## Important Safety Alert – 3<sup>rd</sup> Notice

### VNS Therapy™ Lead Model 302 VNS Therapy Perennia™ Lead Model 303

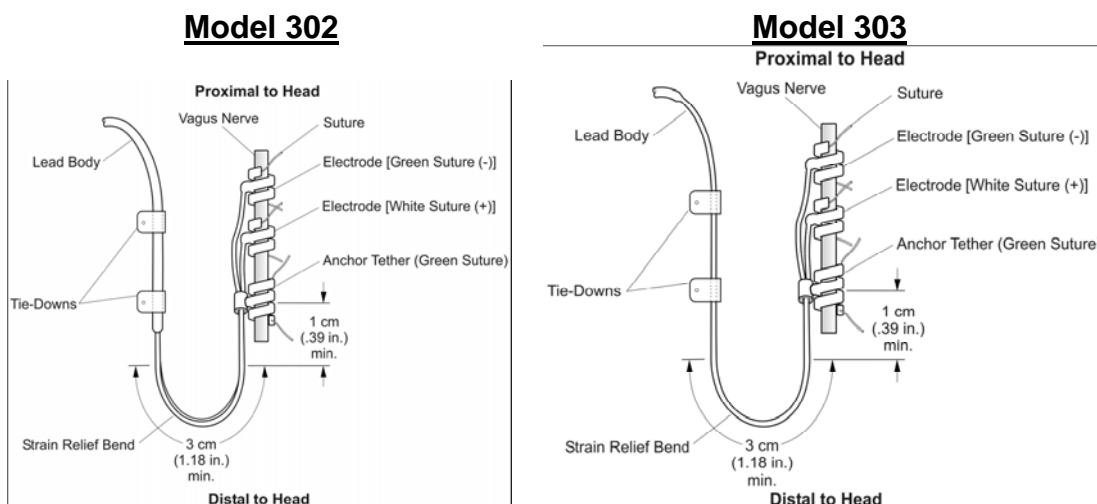
The illustrations in the product labeling have been updated to better demonstrate the recommended strain relief.

Proper techniques include the following:

- 1) Route at least 1 cm of the lead parallel to the nerve.
- 2) Provide at least 3 cm of strain relief bend.
- 3) Place the first tie-down laterally to the anchor tether.
